Application No. A/NE-TKL/837

Section 16 Planning Application for Temporary Open Storage of Recycling Materials and Metalware with Ancillary Facilities and Associated Filling of Land for a Period of 3 Years at Lots 86 (Part), 87 and 89 in D.D. 83 and Adjoining Government Land, Kwan Tei North, Fanling, New Territories

Submission of Further Information 2

Responses to Departmental Comments

Swept Path Analysis

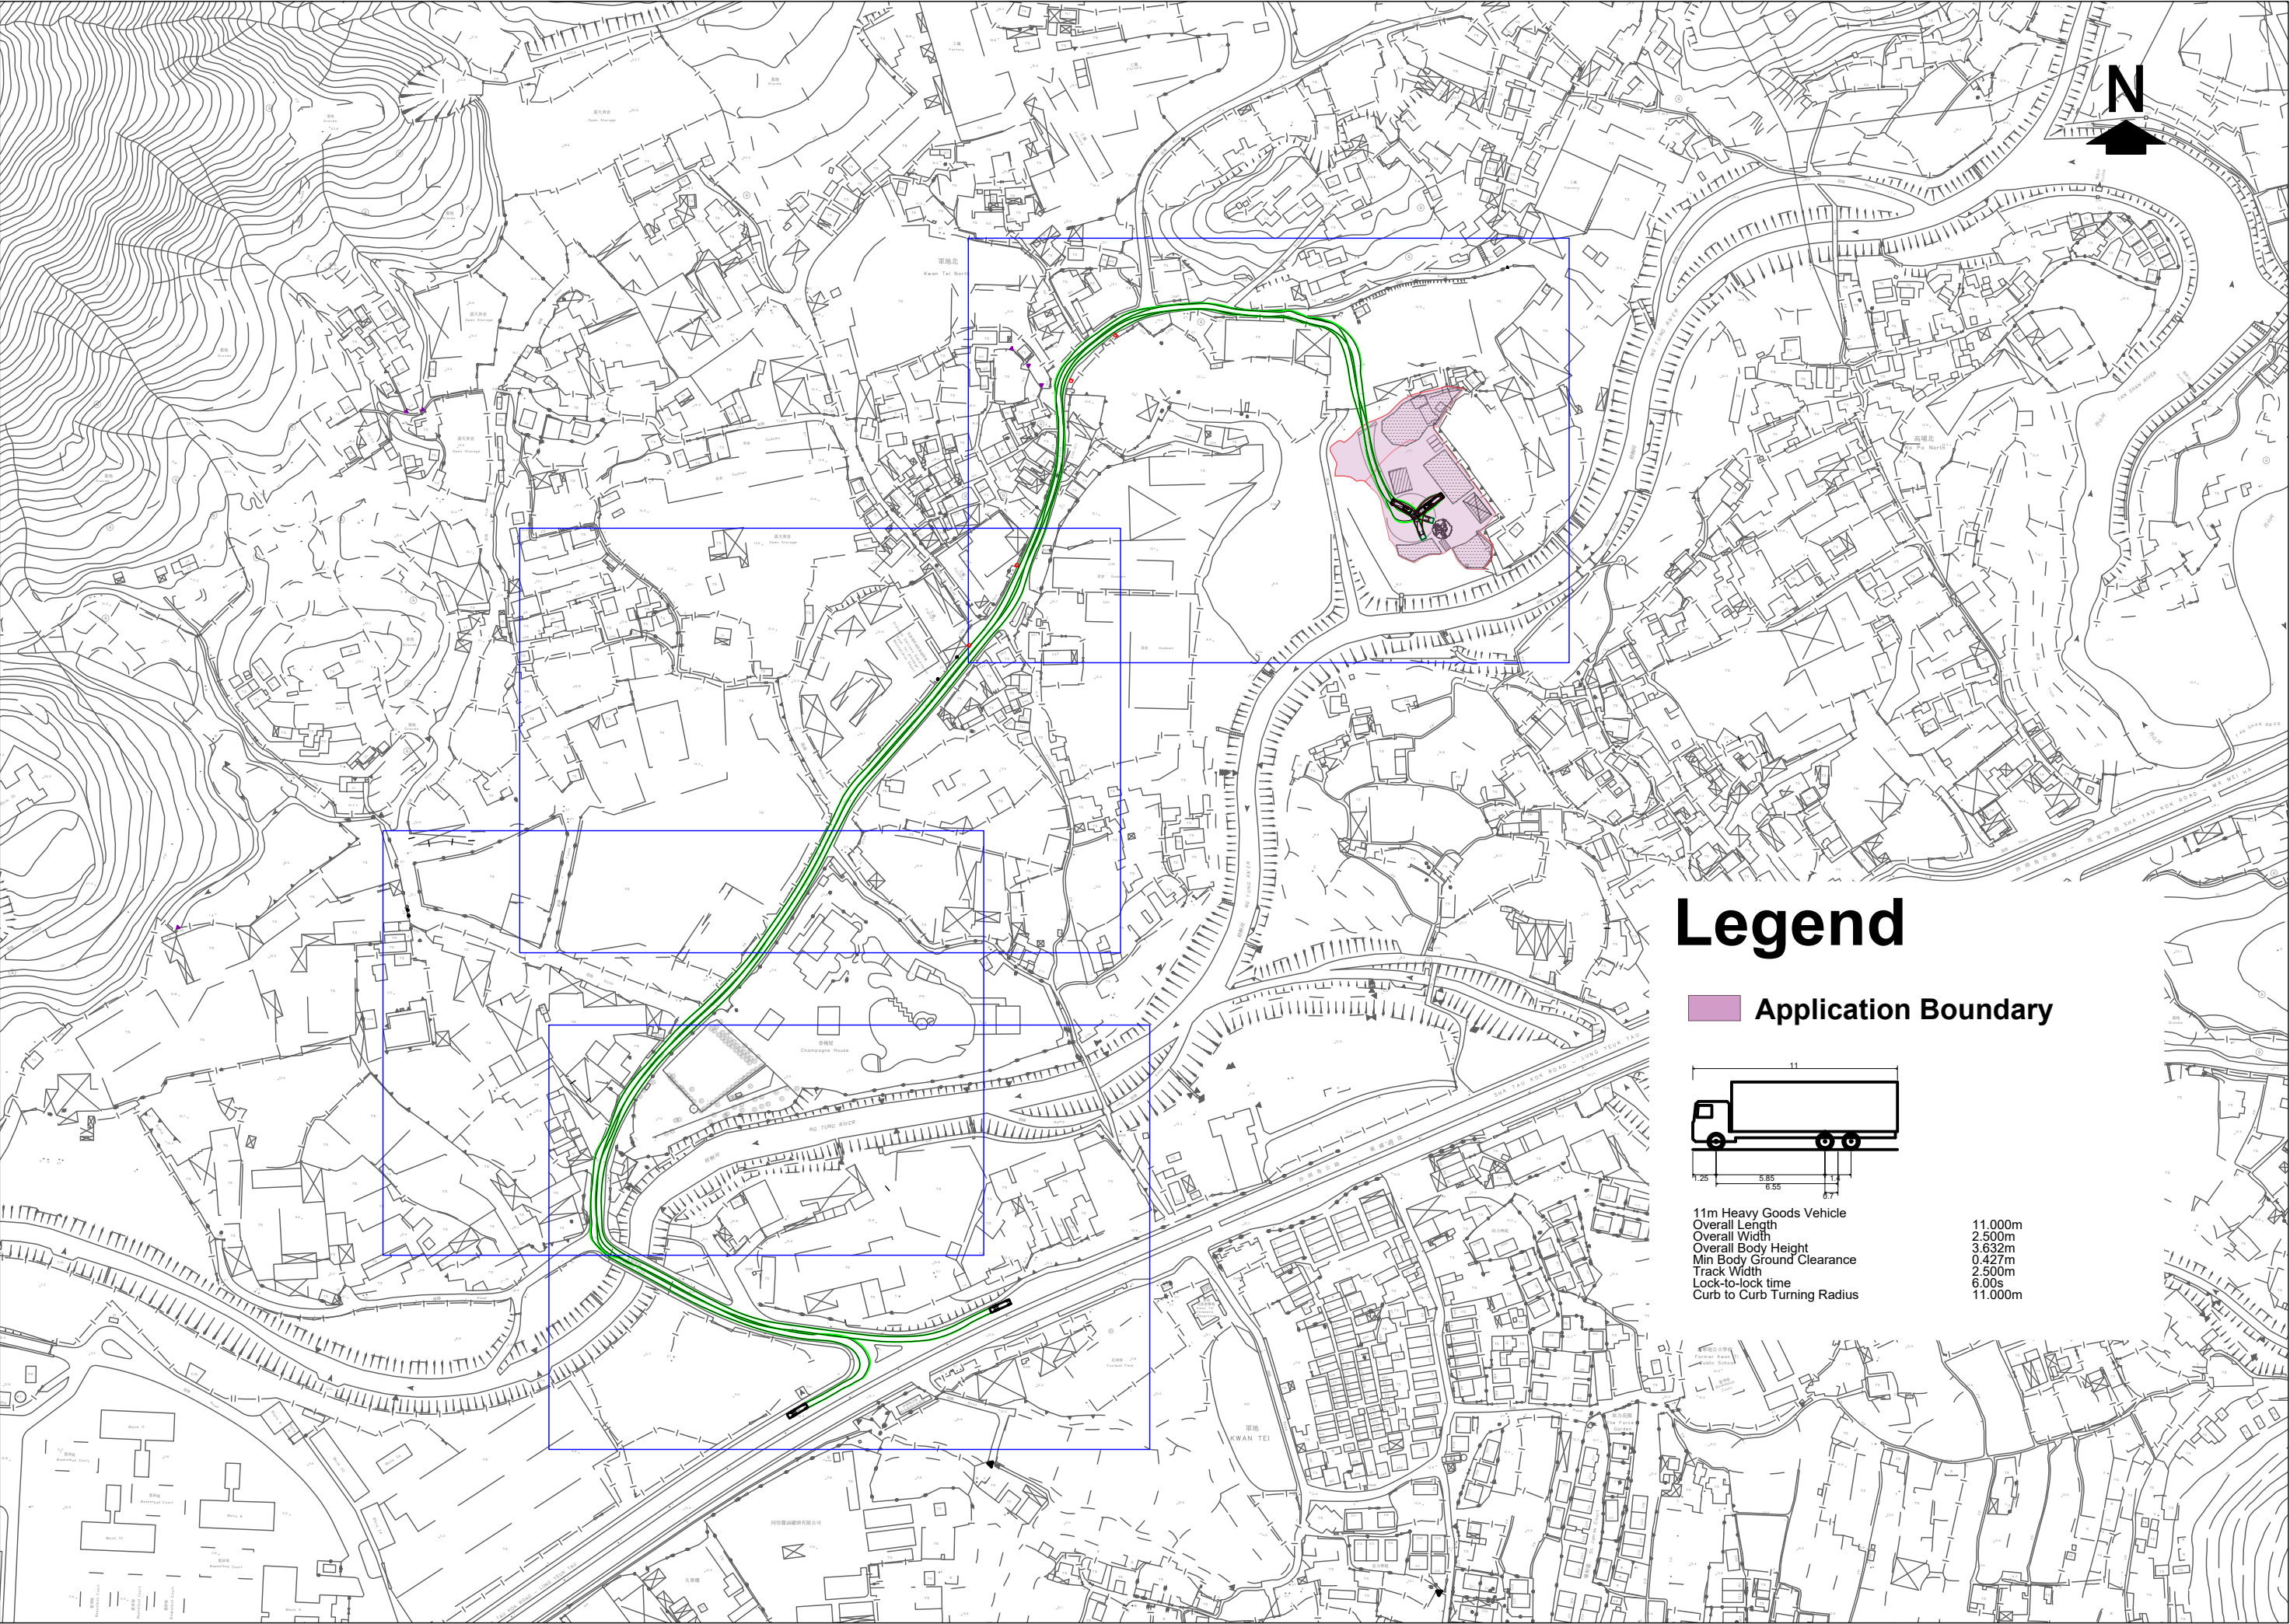
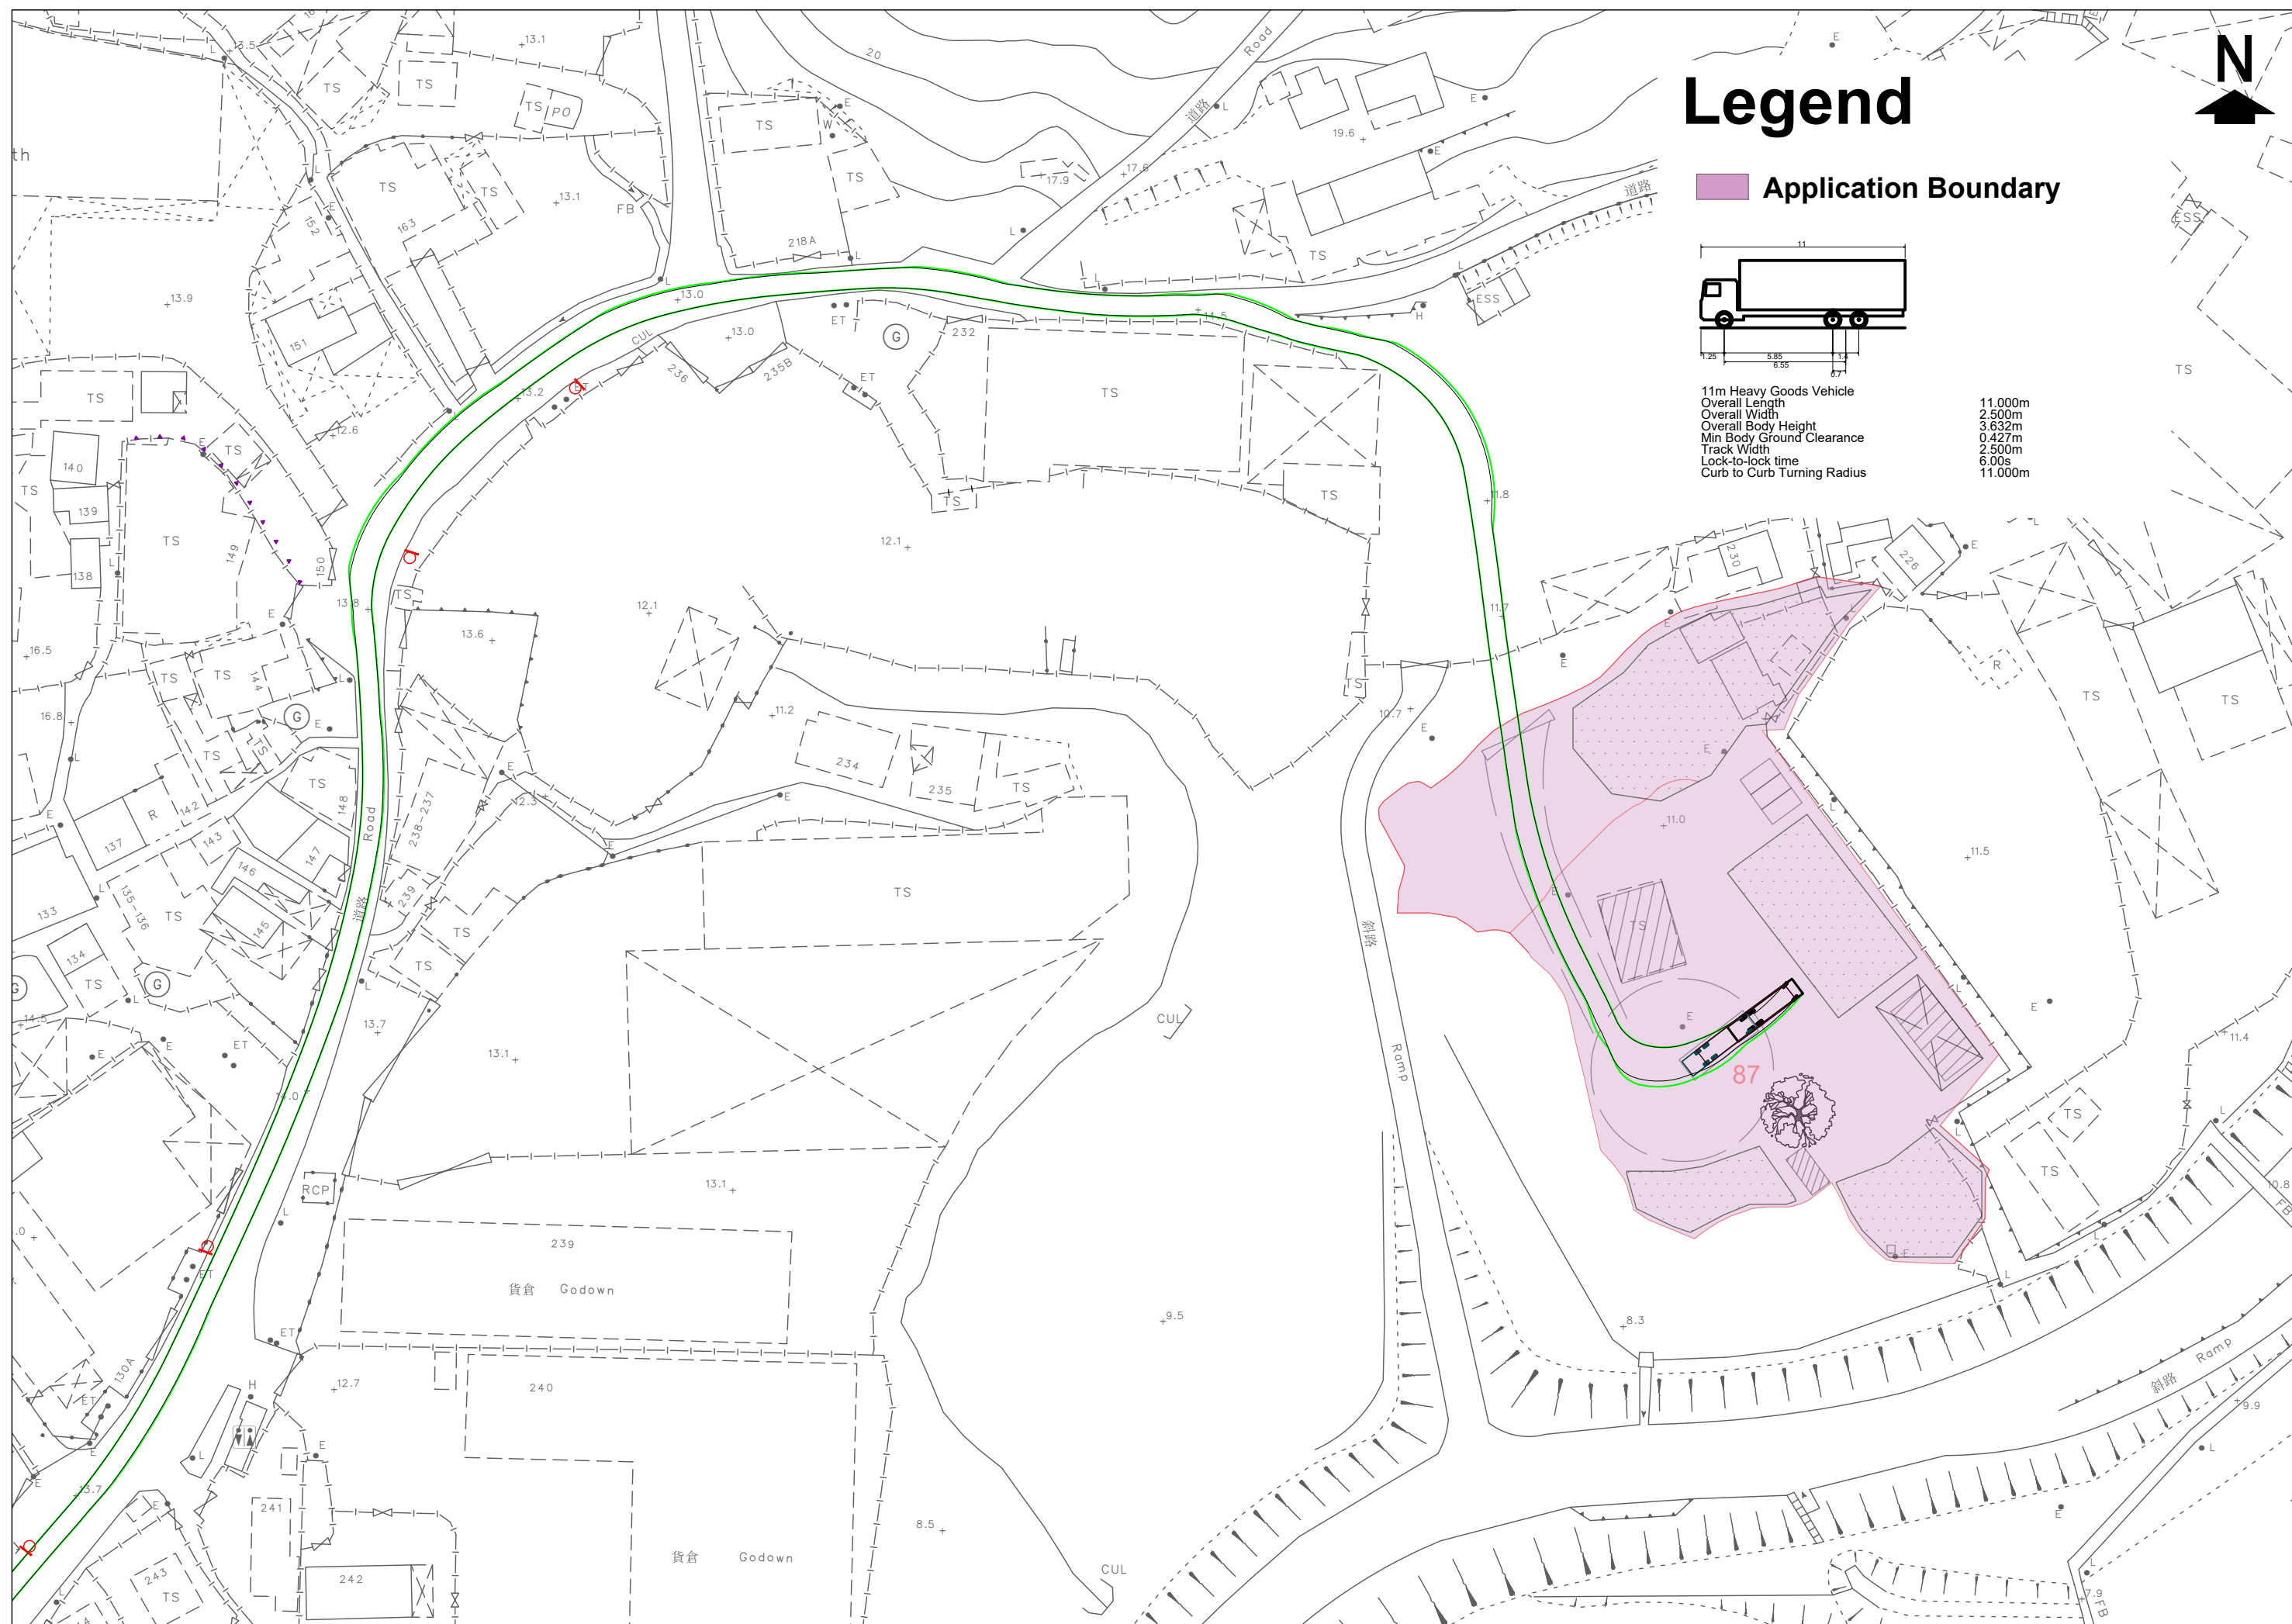
Item	Departmental Comments	Applicant's Responses
1. Comments from Transport Department received on 18.5.2026		
	- the dimension of good vehicles used for swept path analysis should follow the table 5.4.4.1 in Volume 7 of TPDM; and - the applicant should propose measures, such as installation of traffic warning signs and provision of passing bays, to ensure that the movement of site vehicles will not clash with the vehicles riding in opposite direction along the access road linking Sha Tau Kok Road - Lung Yuek Tau to the application site.	The revised swept path analysis is attached at Annex 1 of this FI submission. Please refer to Annex 2 for the proposed traffic warning signs along the access road, which are located on Government land. Upon approval of the application, the Applicant will apply to the relevant departments for permission for the installation of the signage.
